**PROPOSED SOCIAL WELFARE FACILITY (RESIDENTIAL CARE HOME FOR PERSONS WITH DISABILITIES) IN “VILLAGE TYPE DEVELOPMENT” ZONE ON
APPROVED NAM SANG WAI OUTLINE ZONING PLAN NO. S/YL-NSW/10 AT LOTS 3669 S.A RP (PART), 3669 S.B RP (PART), 3670 RP (PART) AND
ADJOINING GOVERNMENT LAND IN D.D.104, NAM SANG WAI, YUEN LONG**

(Planning Application No. A/YL-NSW/348)

Response-to-Comment Table

ELEVATION FROM NB-04 TO NB-15

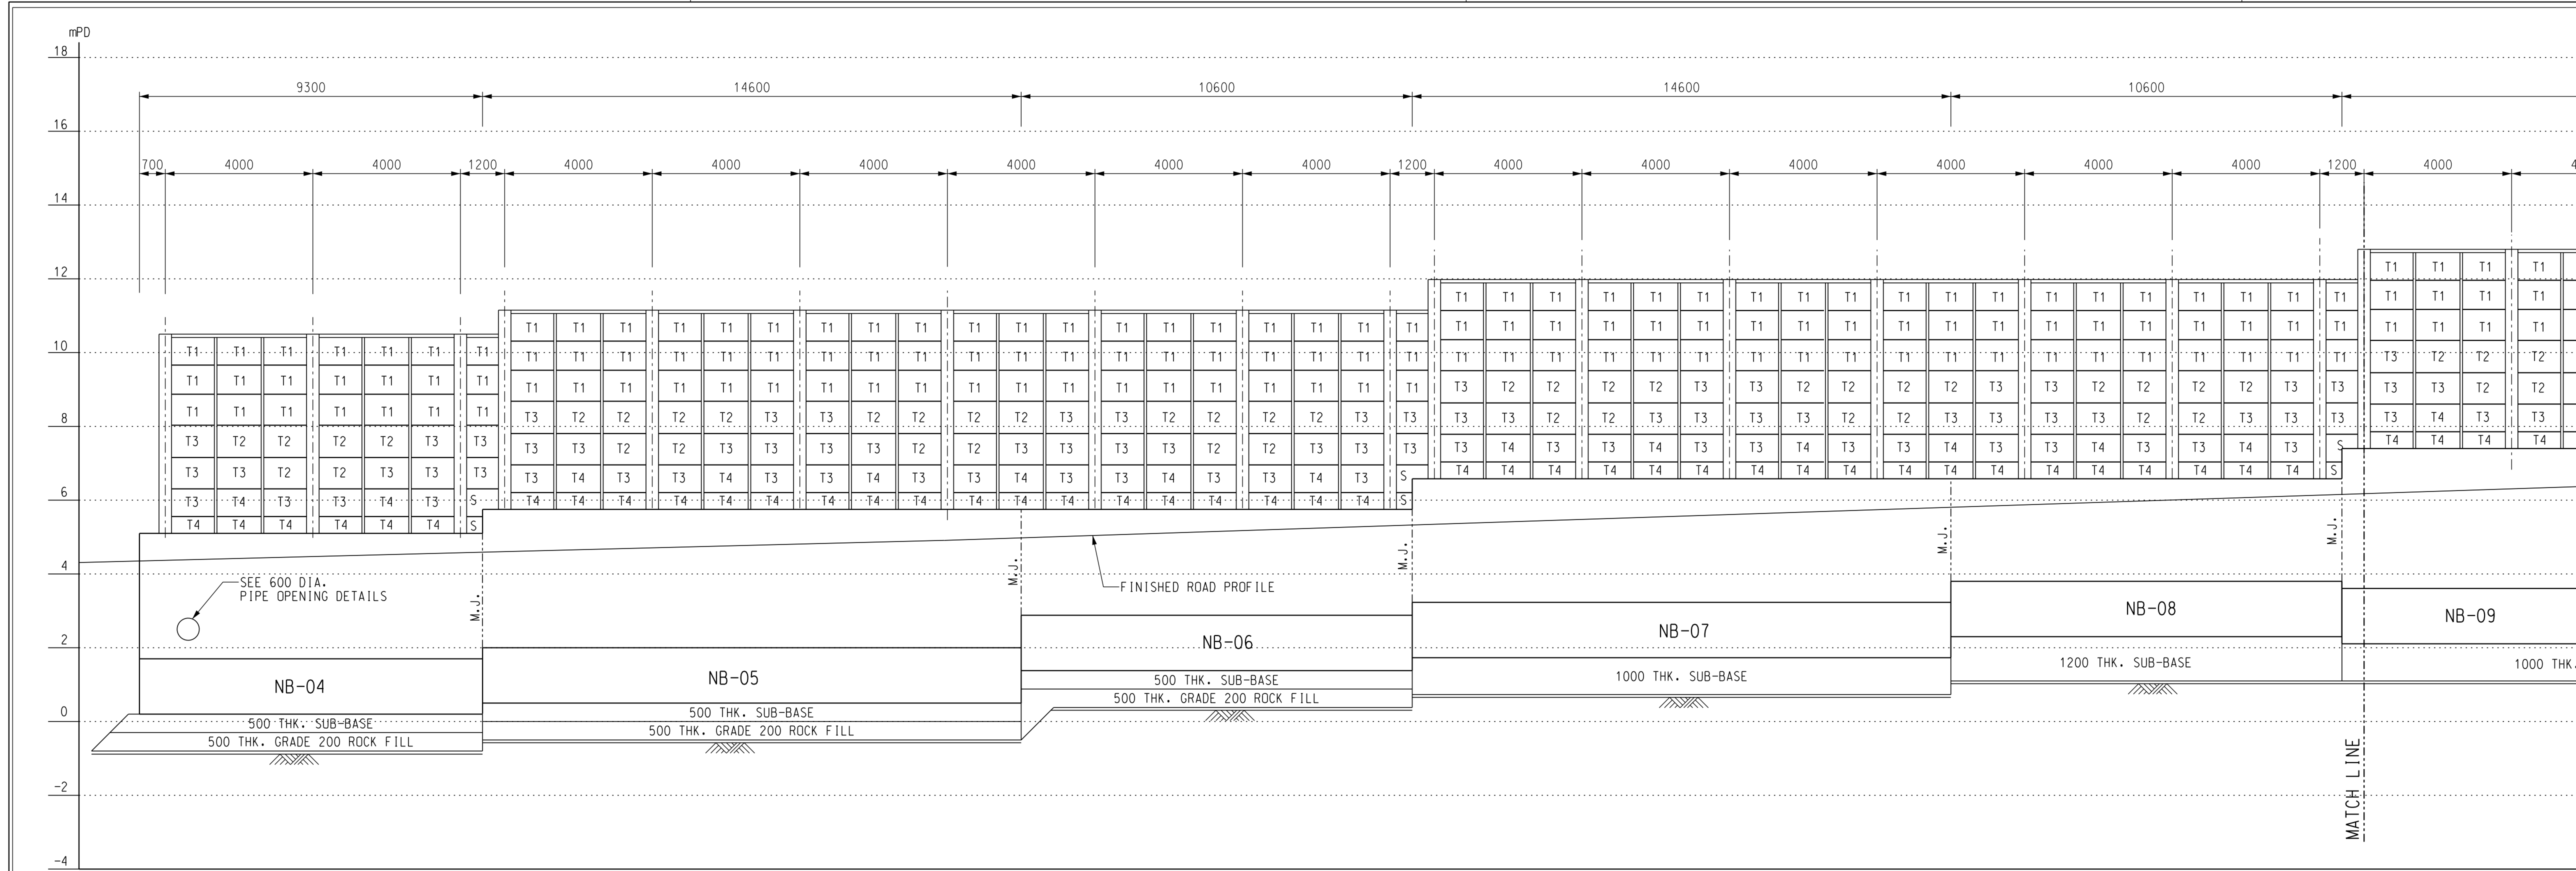
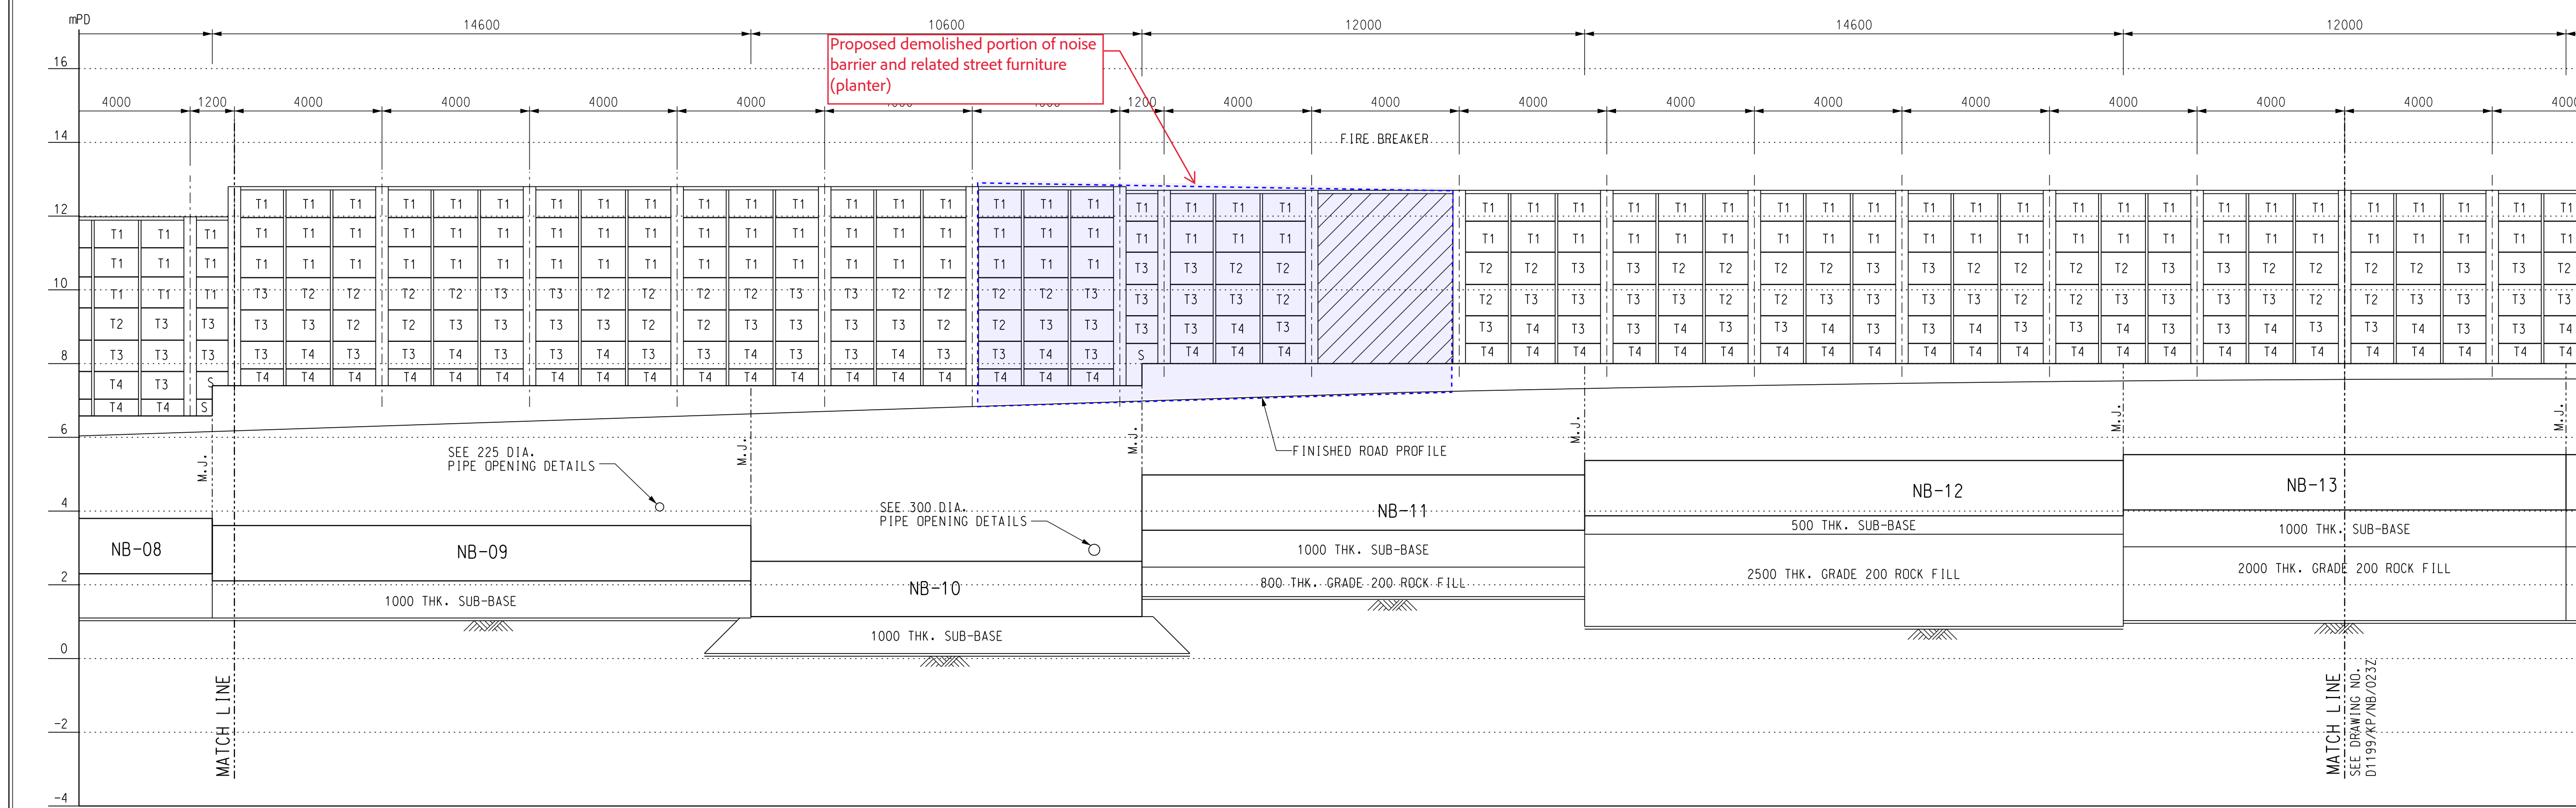
(a) The relevant portions of noise barriers proposed to be removed have not been clearly indicated or marked on the modification plan. Please clarify.	Please refer to Appendix 1 for the Modification Plans of Noise Barrier and Street Furniture.

(c) Please clarify whether the noise implications due to the deletion or removal of existing noise barriers have been assessed in the noise

FIGURE 3.1
LOCATION OF REPRESENTATIVE NOISE
SENSITIVE RECEIVERS

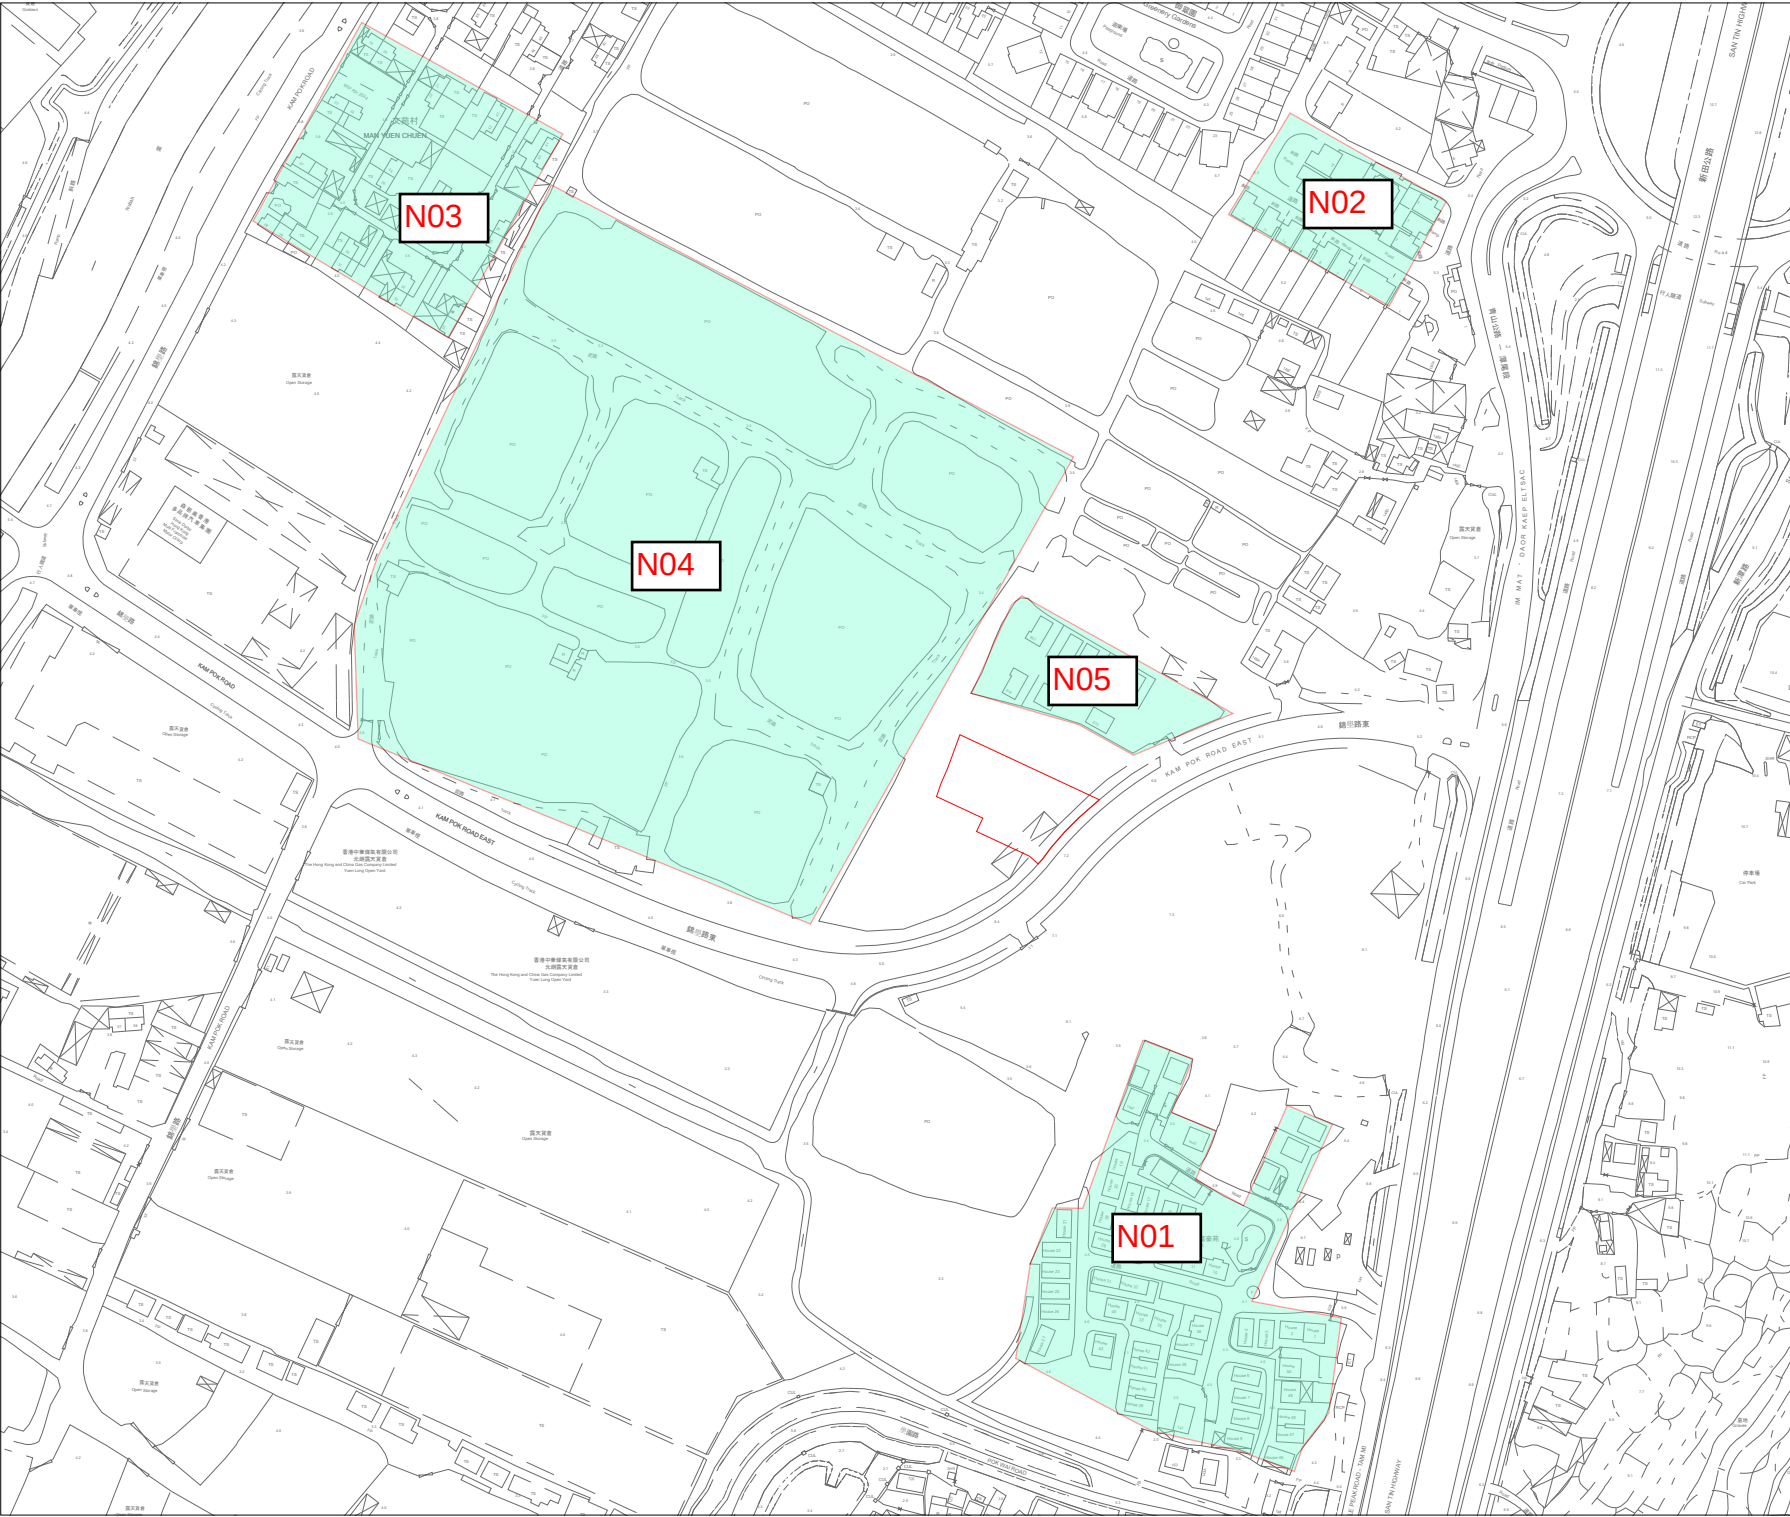
Email dated 7th November 2025 refers: Comment from EPD	Response
General 1. Please highlight/indicate all changes for ease of review.	Noted. Please refer to Appendix 4 for the Revised Environmental Assessment.
Air Quality 1. Please revise the reference error in S.2.4.2	The error has been revised accordingly.
Noise 1. Please review whether the structures in the immediate north of the Site are NSRs.	New NSR is added in Table 3.5 and Figure 3.1.

NOISE BARRIER
LAYOUT PLAN

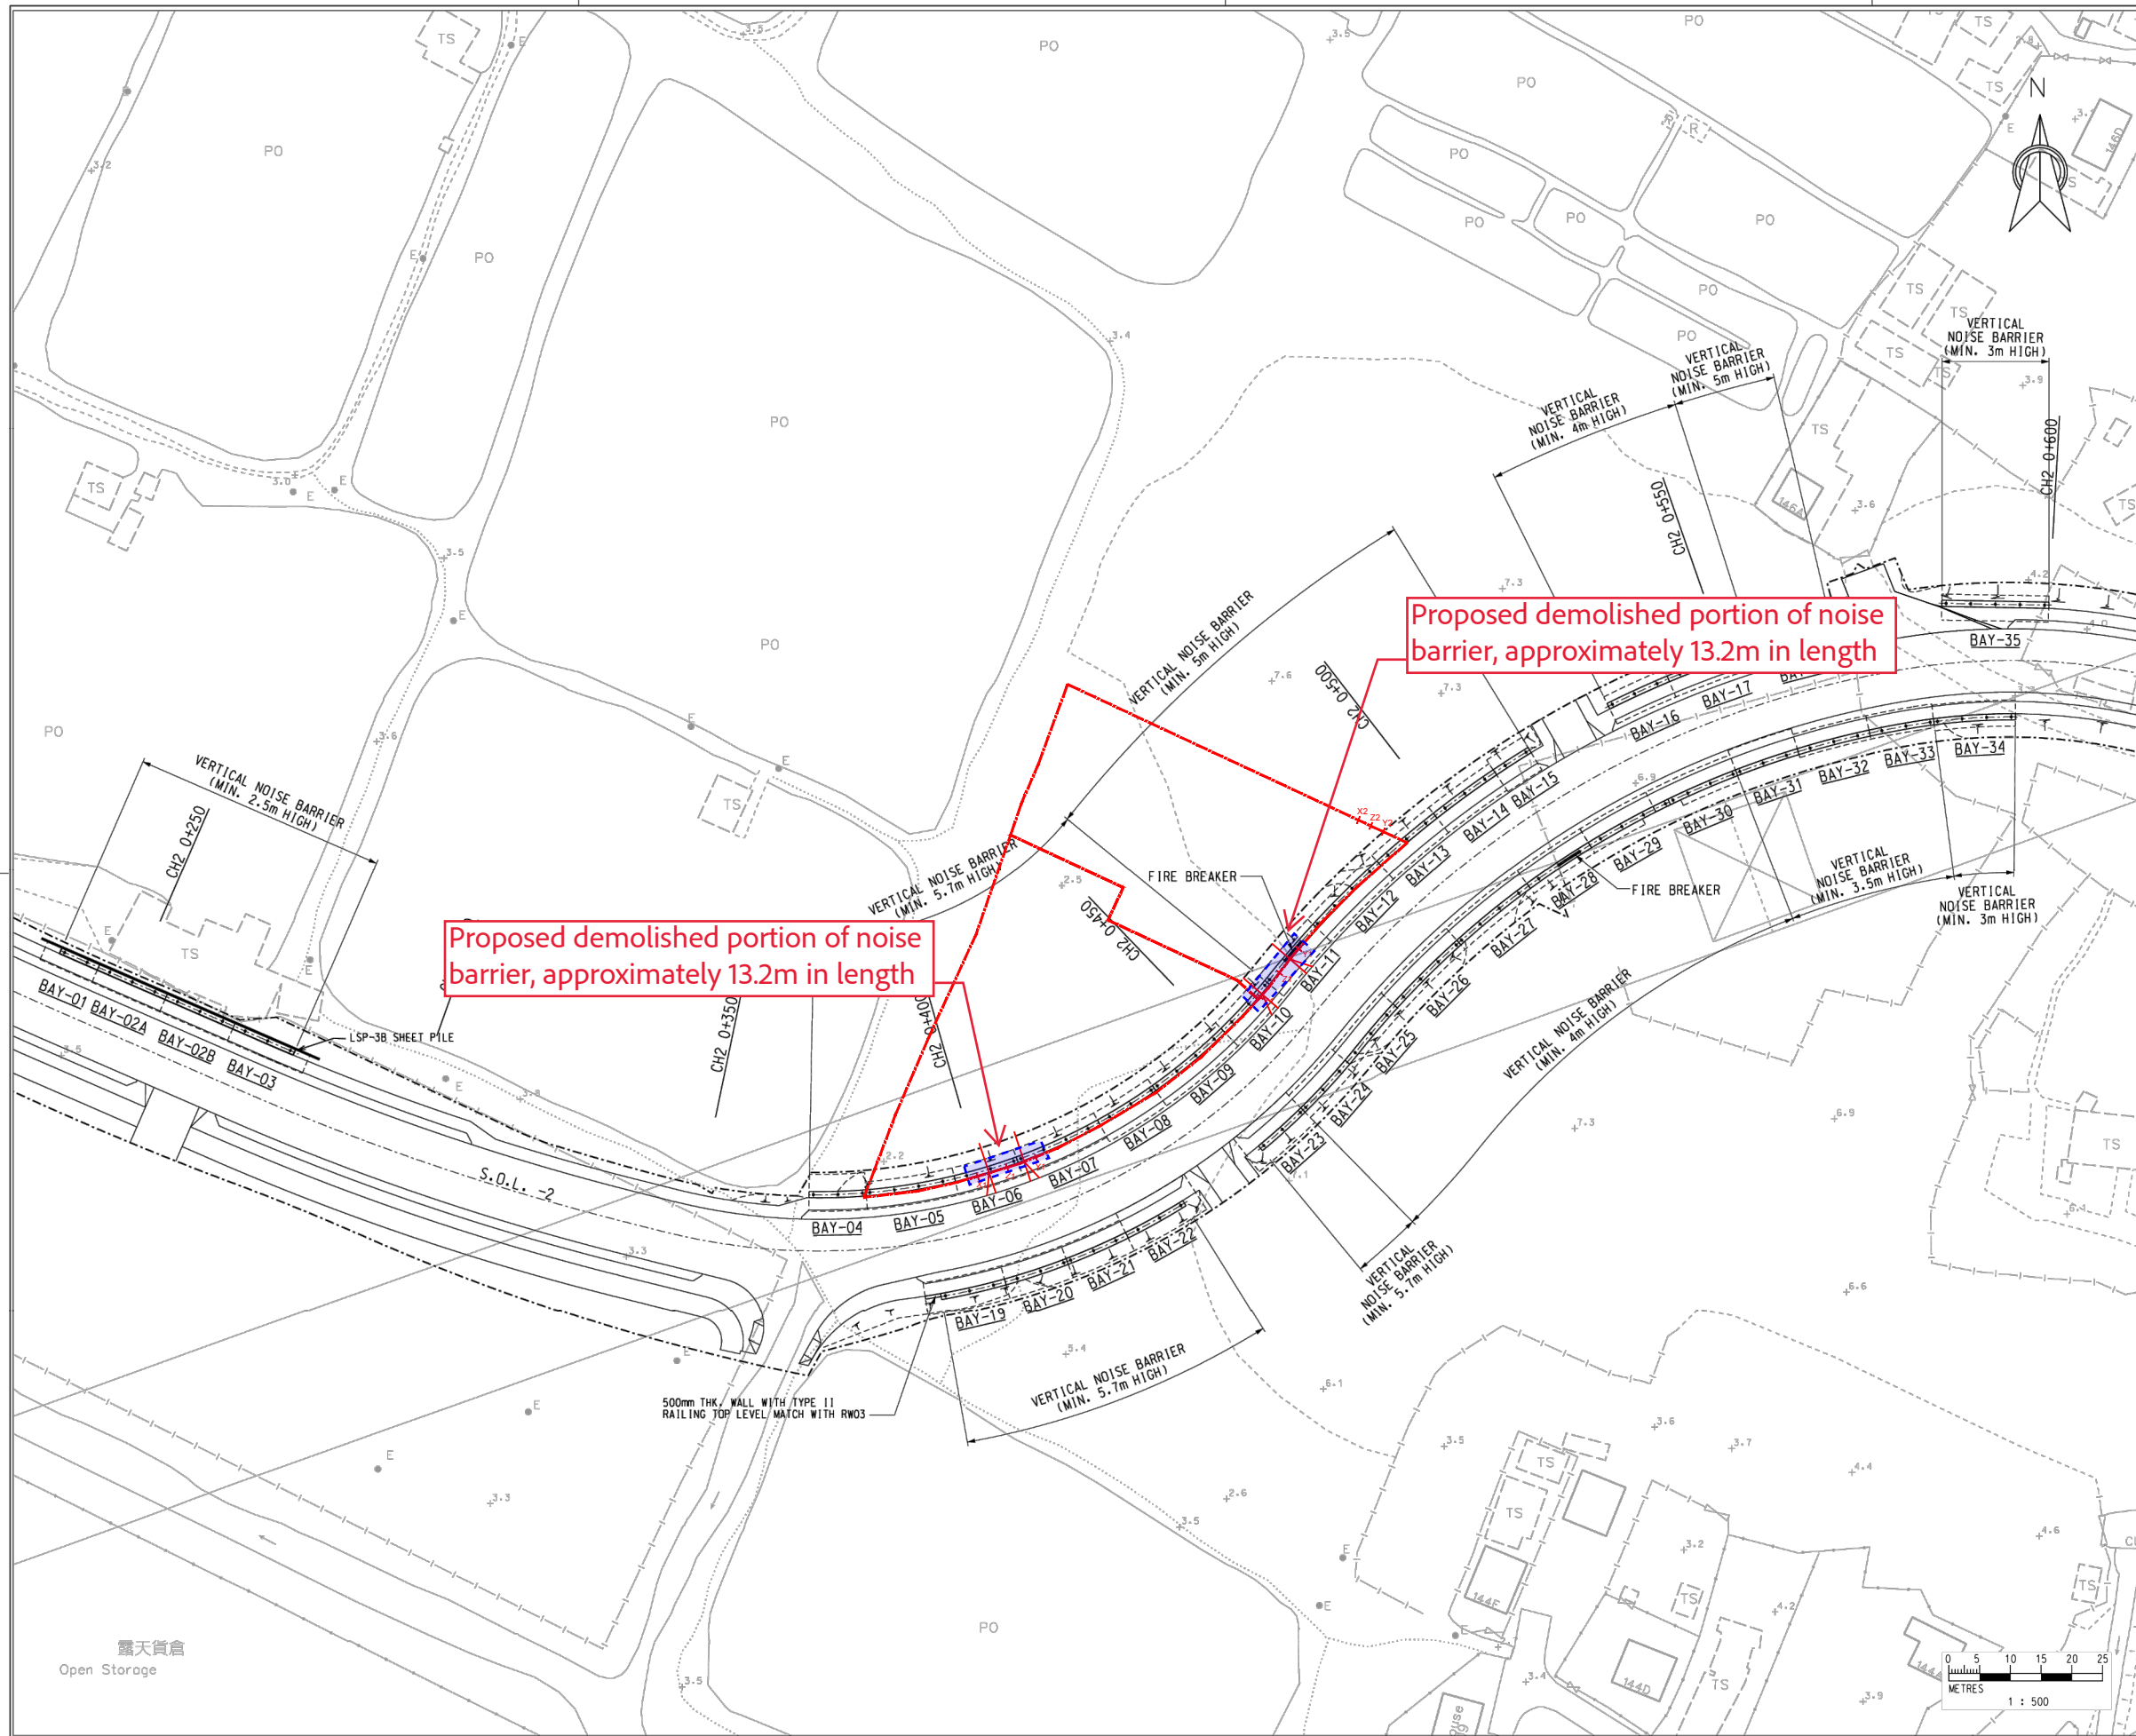
10. Last RtC item 3 in Comments on road traffic noise model i. Please explain if “EVA” stands for emergency vehicle access. ii. For the proposal to remove a portion of the noise barrier for the entrance for EVA, please confirm if this has been discussed with the relevant authority. Additionally, please document this communication.	Yes, “EVA” stands for emergency vehicle access. In relation to the Traffic Impact Assessment and comments from Highways Development, the proposed removal of noise barrier is submitted for comment, the information is provided in S3.4.7. Details of modification please refer to Appendix 3.5.

2. Please check and ensure the site boundary of A/YL/NSW/348 and A/YL/NSW/349 does not overlap in the model.	Noted.
3. There are breaks on the noise barrier in the model, please check, and revise if needed.	Refer to building plan in Appendix, part of the noise barrier will be removed for entrance of EVA.

1. The applicant should ensure the run-in/out at Kam Pok Road East is constructed in accordance with the latest version of HyD Standard Drawings no. H1113 and H1114, or H5133, H5134 and H5135, whichever set if appropriate to match with the existing adjacent pavement;	Noted.
2. It is noted that there are existing noise barriers under HyD's maintenance purview at the south-east boundary of the site, adjoining Kam Pok Road East. Please advise if there are any modification or alteration of the noise barriers among other road features (e.g. the existing footpath/ carriageway adjoining the site) be required arising from the proposed development.	Please refer to Appendix 3 for the Modification Plans of Noise Barrier and Street Furniture.
